**MONTGOMERY COUNTY HISTORIC PRESERVATION COMMISSION**  
**STAFF REPORT**

<b>Address:</b>	17 West Kirke Street, Chevy Chase	<b>Meeting Date:</b>	3/20/2024
<b>Resource:</b>	Contributing Resource <b>Chevy Chase Village Historic District</b>	<b>Report Date:</b>	3/13/2024
<b>Applicant:</b>	Chuck Muckenfuss & Angela Lancaster (Dustin Hirt, Architect)	<b>Public Notice:</b>	3/6/2024
<b>Review:</b>	Historic Area Work Permit	<b>Tax Credit:</b>	Partial
<b>Case Number:</b>	1060991	<b>Staff:</b>	Dan Bruechert
<b>Proposal:</b>	Partial deck and rear elevation demolition, construction of new elevator shaft, new pergola, fenestration and other alterations.

**STAFF RECOMMENDATION**

PARTIAL BASEMENT FLOOR PLAN

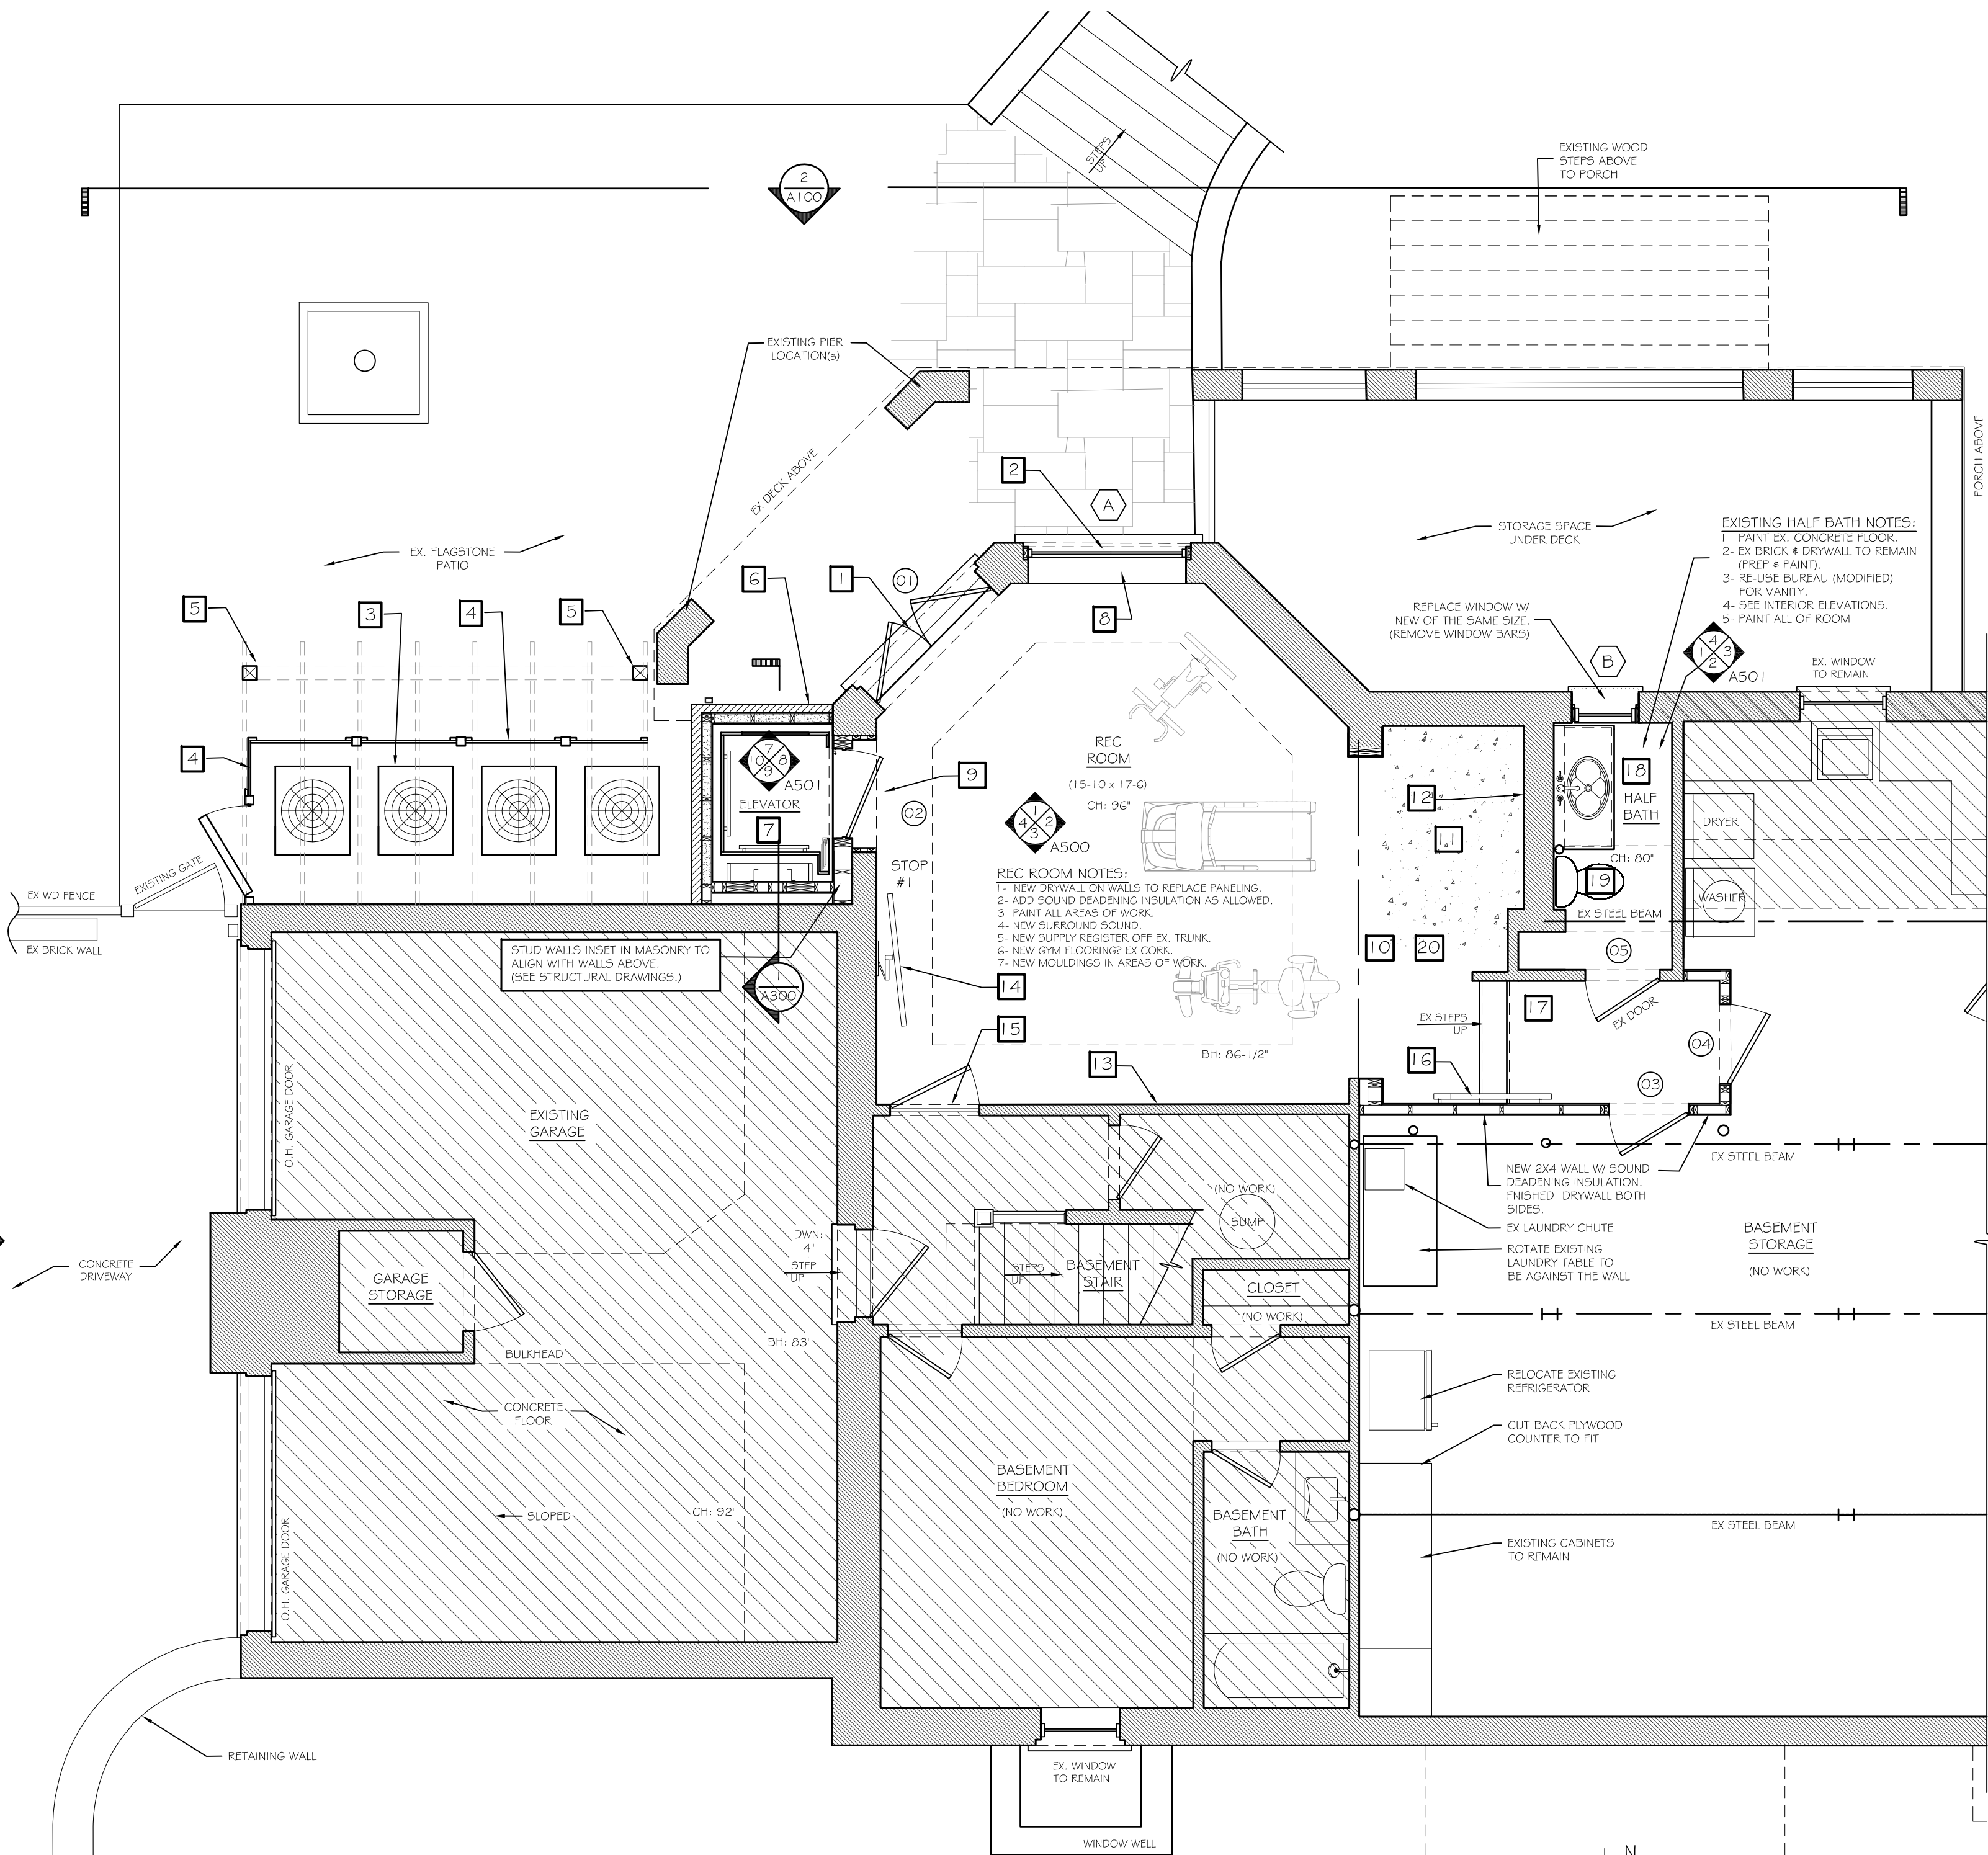
In the basement, underneath the non-historic rear deck, there is a pair of single-light French doors that appear to date to the 1991 addition. The applicant proposes to remove these doors and install a large, wood picture window. The notes on the plans indicate the French doors will be stored in the garage. This feature is both below grade and on the rear of the property. Staff finds the existing doors are not historic and do not contribute to the historic character of the house. Staff further finds the proposed replacement window is compatible with the character of the site and surrounding district under a lenient scrutiny review.

1. Detailed window specifications that show permanently affixed exterior and interior grilles with an interior spacer bar shall be submitted to Staff for review and approval before issuing the final HAWP.

**PARTIAL SECOND FLOOR PLAN**  
SCALE: 1/4" = 1'-0"

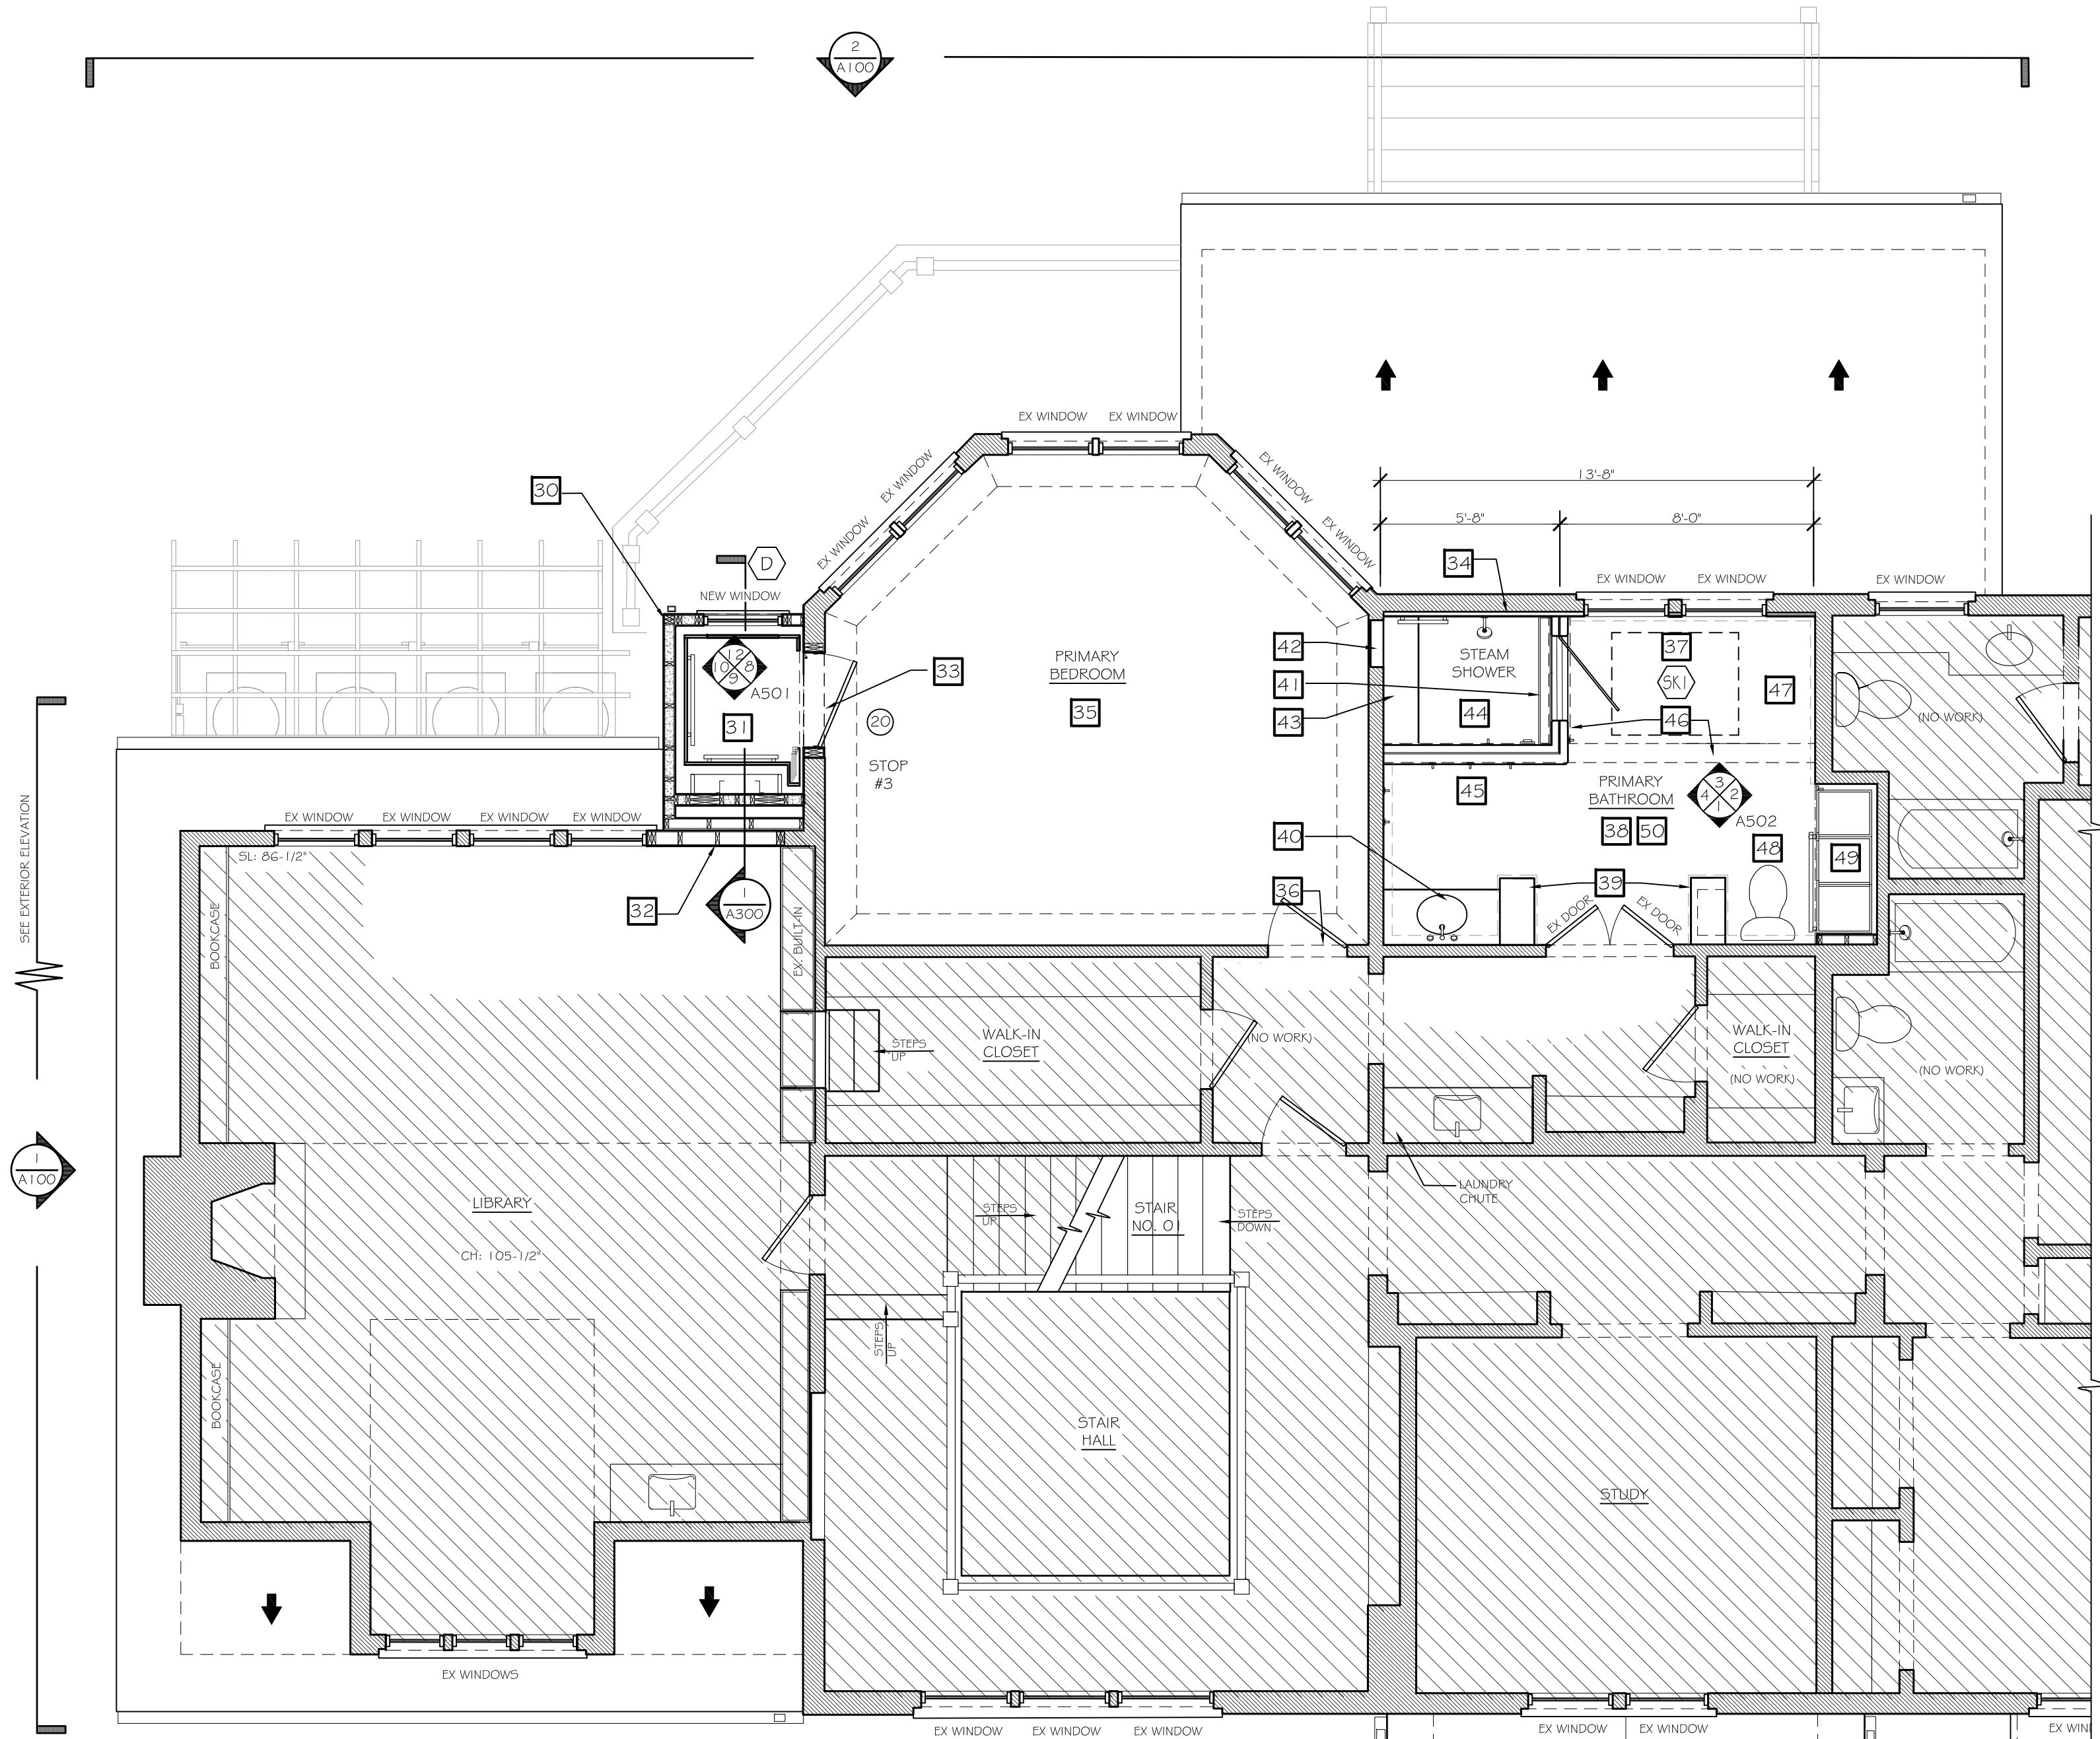
The final change on the rear is the removal and replacement of a non-historic skylight on the rear. The drawings and window schedule indicate the skylight will be replaced with a Velux skylight that matches the dimensions of the existing one. Staff finds that this change would be a replacement in-kind that is eligible for the County's Historic Preservation Tax credit, however, full dimensions and details were not submitted with the material specifications. Detailed specifications for the skylight replacement need to be included with the final permit documents before the final HAWP can be issued.

4. Detailed specifications for the proposed skylight showing it matches the existing one shall be submitted to Staff for review and approval before issuing the final HAWP. If Staff verifies the replacement skylight is a replacement in-kind, the skylight replacement is eligible for the County's Historic Preservation Tax Credit;
